Sheldon YOURIST et al. Appl. No. 10/662,879

Amendments to the Drawings:

REMARKS/ARGUMENTS

This is in response to the Office Action mailed October 15, 2004. Claims 22-24 have been withdrawn. Claims 1 and 25 have been amended to further particularly point out and distinctly claim the subject matter which applicant regards as the invention. These claims do not include any amendments for a purpose of limiting the inventive subject matter, but rather are intended to emphasize certain aspects of the invention already set forth in the claims. Support for the amendments can be found throughout the originally filed application, e.g., Figures 1, 2, 8, 9 and 10A. No new matter has been added.

FIG. 2

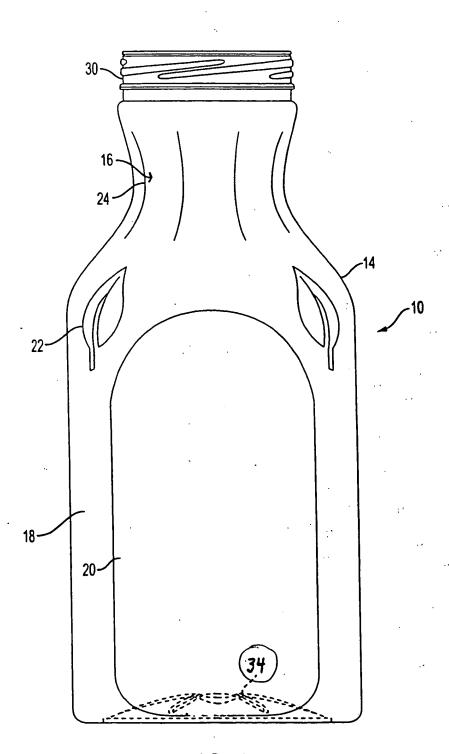
Applicants have also amended Figure 10B and paragraph 30 to replace the description to reference of feature "I-I" with "10C-10C". Figure 5 has been amended to remove reference to feature "32". Figures 1-2, 6, 8, and 9-11 have been amended to replace handwritten notations with typed text. Also, contour lines have been removed from Figures 10A and 10B.

FIG. 9

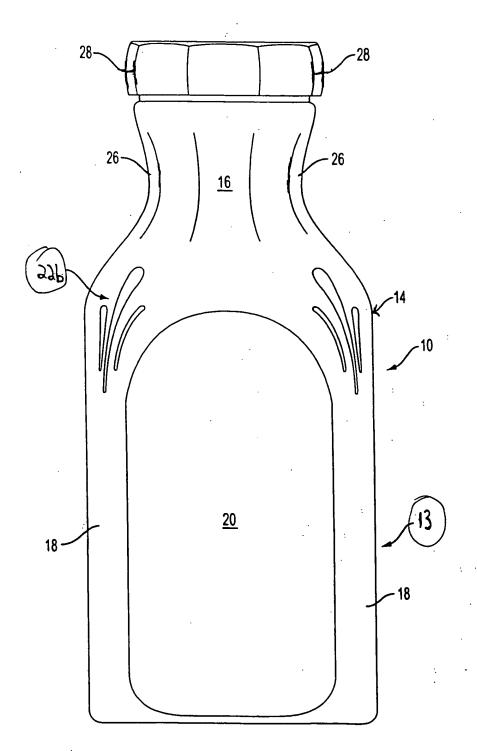
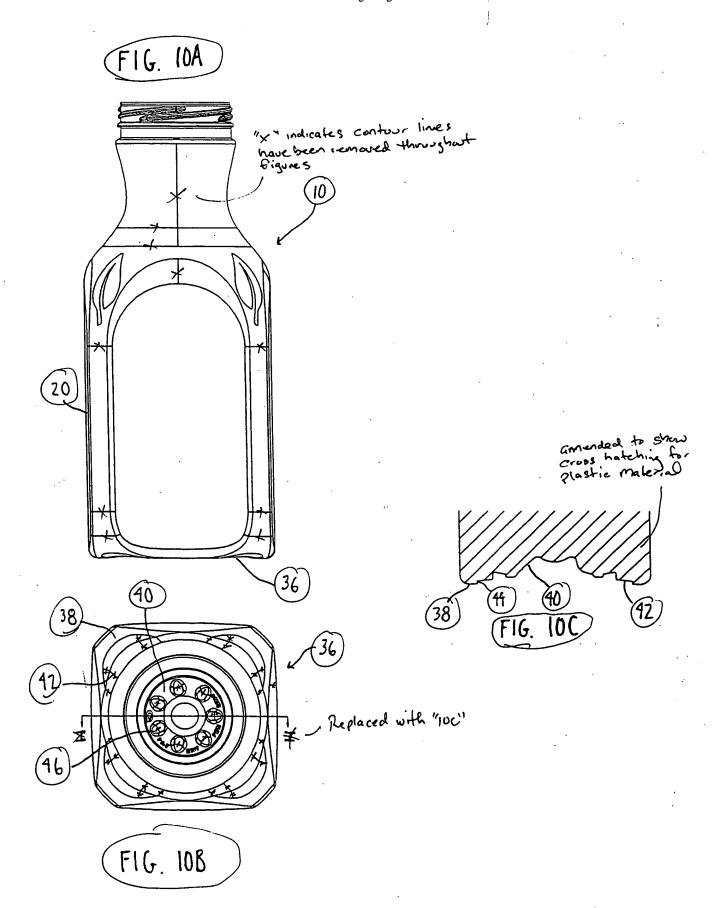
The Examiner has also objected to the drawings because "the features '22c' and '23 "do not appear to have been identified." The feature "23" is another embodiment of the invention that is not shown in the figures. Paragraph 48 has been amended and replaced by a new paragraph that does not reference feature "23." Paragraph 44 includes a typographical error referencing feature "22c." New paragraph 44 is presented referencing the correct features of "22a" and "22b." This amendment also addresses the Examiner's objection that "the feature '22a' doesn't appear to have been described." Feature "22a" is now described in amended paragraph 44. Also, a typographical error referencing "Fig. 3" has been corrected to reference "Fig. 9."
